Form 3160-5  
(June 2019)

**SUNDRY NOTICES AND REPORTS ON WELLS**  
**Do not use this form for proposals to drill or to re-enter an abandoned well. Use Form 3160-3 (APD) for such proposals.**

Betty 5 Fed Com 202H (FKA Getty 5 Fed Com 757H) API #: 30-025-52011

EOG respectfully requests an amendment to our approved APD for this well to reflect the following changes:

## WELL LOCATION AND ACREAGE DEDICATION PLAT

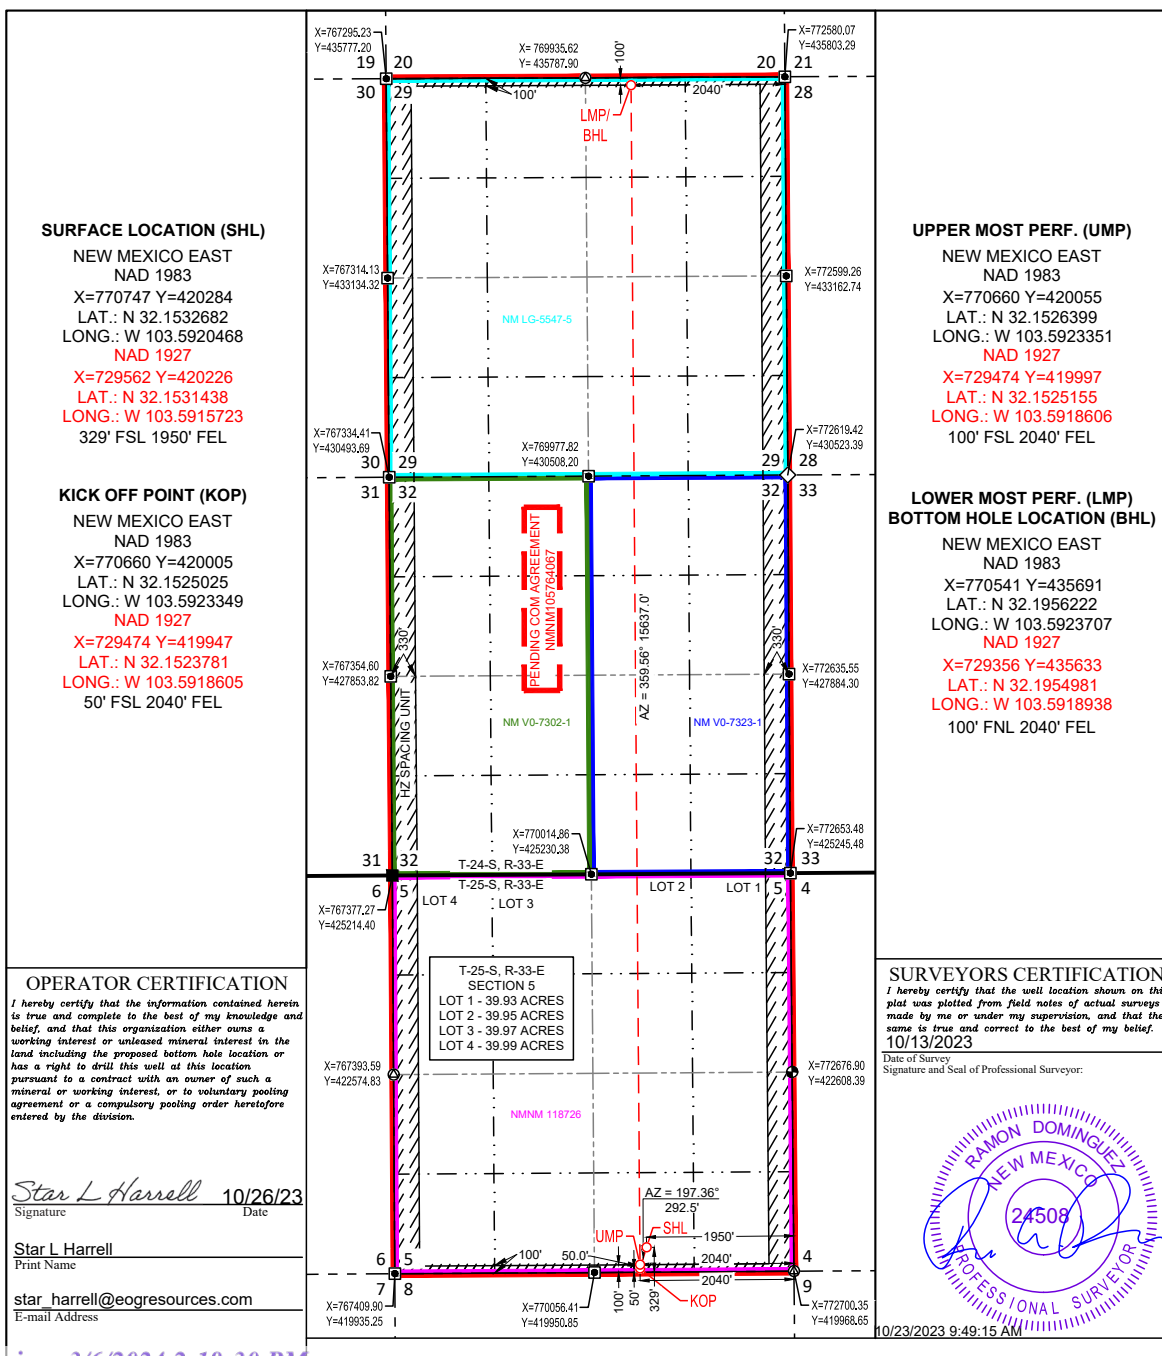
Change SHL from T-24-S, R-33-E, Sec 5, 1313' FSL, 1563' FWL, Lea Co., NM, to T-25-S, R-33-E, Sec 5, 329' FSL, 1950' FEL, Lea Co., N.M.

Change BHL from T-24-S, R-33-E, Sec 32, 2540' FSL, 331' FWL, Lea Co., NM, to T-24-S, R-33-E, Sec 29, 100' FNL, 2040' FEL, Lea Co., N.M.

Update the Pool as reflected in the C-102.

### Proposed 11" Hole with 9.625" 40# J55/HCK55 LTC Casing

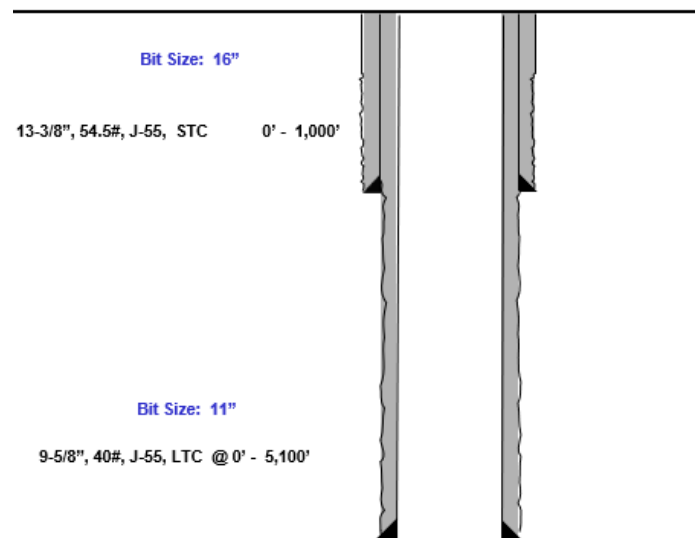
**EOG request permission to allow deviation from the 0.422" annulus clearance requirement for the intermediate (salt) section from Onshore Order #2 under the following conditions:**

- 11" Bit + 0.52" Average hole enlargement = 11.52" Hole Size
  - 0.9475" Clearance to casing OD

$$= \frac{11.52 - 9.625}{2}$$
  - 0.4475" Clearance to coupling OD

$$= \frac{11.52 - 10.625}{2}$$
- Previous Shoe – 13.375" 54.5# J55 STC
  - 0.995" Clearance to coupling OD (~1,200' overlap)

Proposed 9.875" Hole with 8.625" 32# J55/P110 BTC-SC Casing

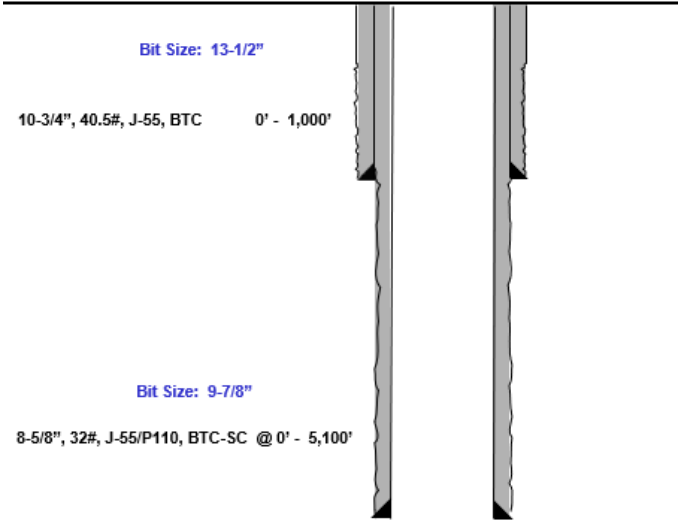
- 9.875" Bit + 0.42" Average hole enlargement = 10.295" Hole Size
  - 0.835" Clearance to casing OD
    - =  $\frac{10.295 - 8.625}{2}$
  - 0.585" Clearance to coupling OD
    - =  $\frac{10.295 - 9.125}{2}$
- Previous Shoe – 10.75" 40.5# J55 STC
  - 0.4625" Clearance to coupling OD (~1,200' overlap)
    - =  $\frac{10.05 - 9.125}{2}$
